Description of Permissive Change

This report is prepared for FCC class II permissive change. The difference compared with the original design listed as below:

Report No.: RF970819L04A

FCC ID: K7SF5D8635-4A

Item 2

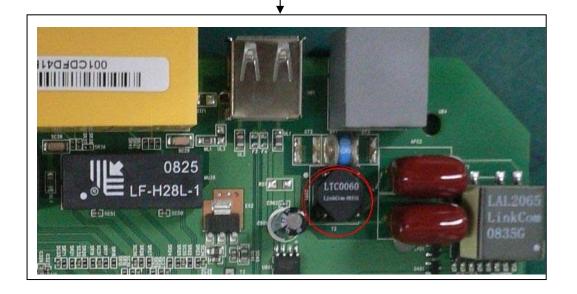
ITEM	CLASS II CHANGE DESCRIPTION
1	Remove fuse for over-current protection at power jack
2	Add common mode choke at RJ-11

Add common mode choke
